**SERVICE BULLETIN NUMBER CT124**

**TITLE** Flap up limit cable  
**CLASSIFICATION** The CAA have classified this bulletin as Mandatory.  
**COMPLIANCE** Inspection before further flight;replacement within 5 hrs if affected.  
**APPLICABILITY** All CT2K up to Flight Design serial no. 03-07-03-34, P&M serial 8124 inclusive.

Fig 1. Limit Cable Installation

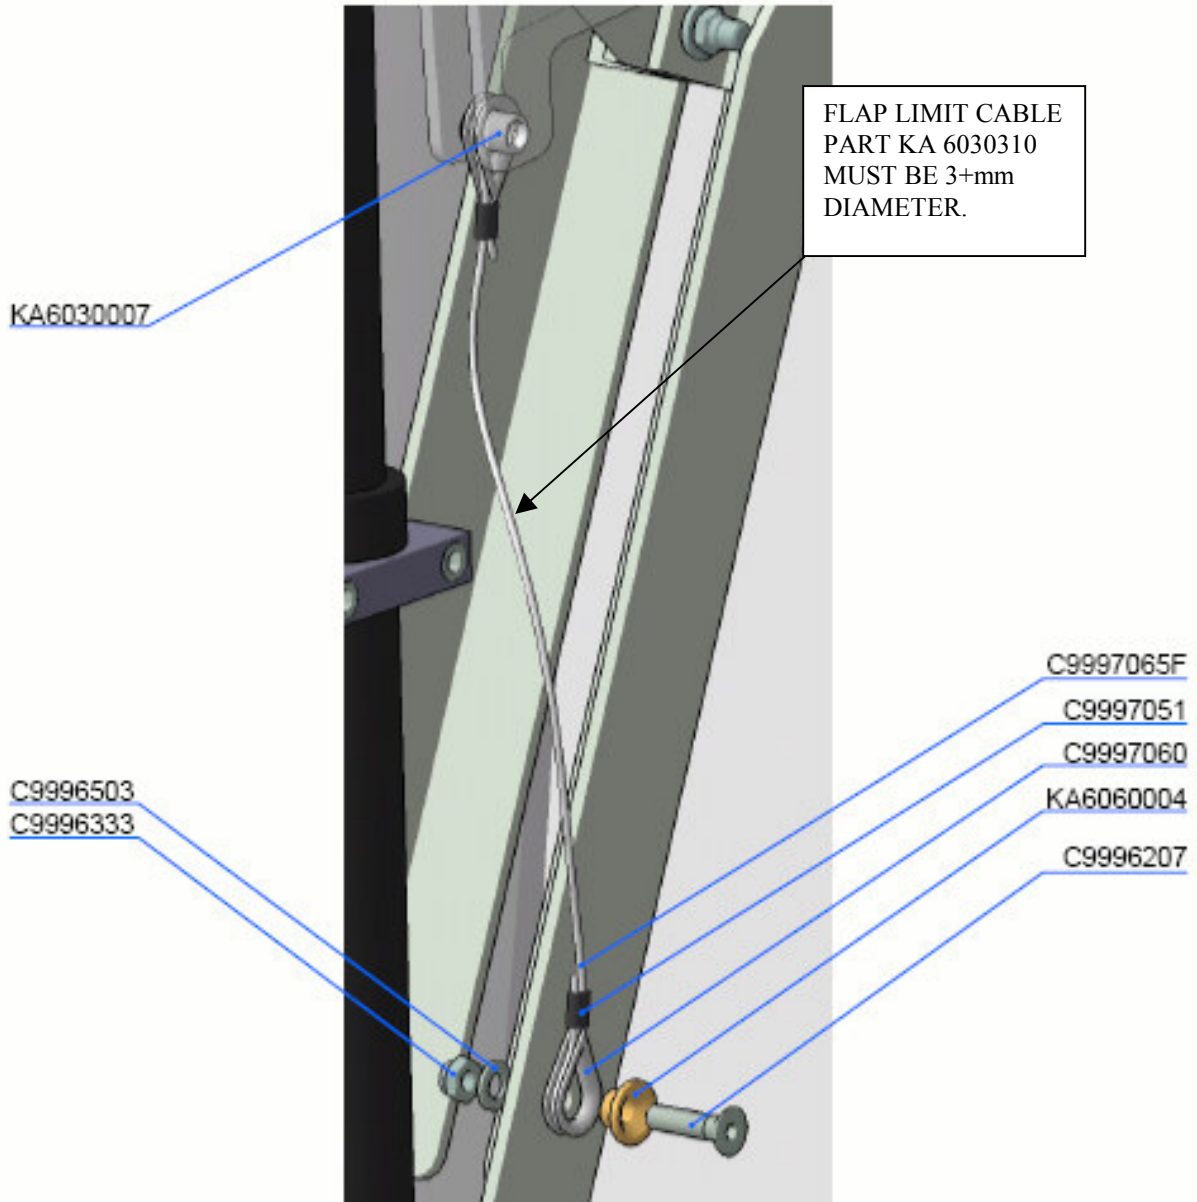
The electric flap system on the CT2K is provided with a flexible steel cable which limits the UP flap travel in the event of failure of the limit switch. Some examples of CT2K were manufactured with a 1.5mm strop which can break under some circumstances, if the limit switch fails.

In the event of failure of the UP flap limit switch, it has been found that although the flap motor circuit breaker will trip when run against the 1.5mm cable, subsequent repeated selection of UP flap will cause the cable to break. The flaps will then run beyond the normal -12° setting until stopped by the motor internal stop. More than -12° flap setting reduces performance and increases stall speed.

Before further flight, inspect the flap UP limit cable and measure the diameter using a vernier calliper. It should be 3 – 3.5mm. See fig 1.

If a smaller cable is installed, it must be replaced within the next 5 flying hours. The cable length is set up on each individual aeroplane to allow for production build tolerances.

If the cable is too small, it must be replaced with a new cable part. KA 6030310 according to modification M109. Provided the flap system is working normally and the flaps UP position is stopped by the limit switch and not the cable, it is permissible to ferry fly the aeroplane to P & M or a P & M approved facility to enable the modification to be carried out. Alternatively the cable should be removed and sent by recorded delivery to P & M Aviation Ltd, where a new 3mm cable assembly part. KA 6030310 will be made up to match it.

When the cable is replaced, a full functional check of the flap system must be made, including deflection according to TADS BM65 (UP -60mm +-5, DOWN +175mm +-10, relative to fuselage fillet trailing edge), limit switch operation, LED indications and flap symmetry.
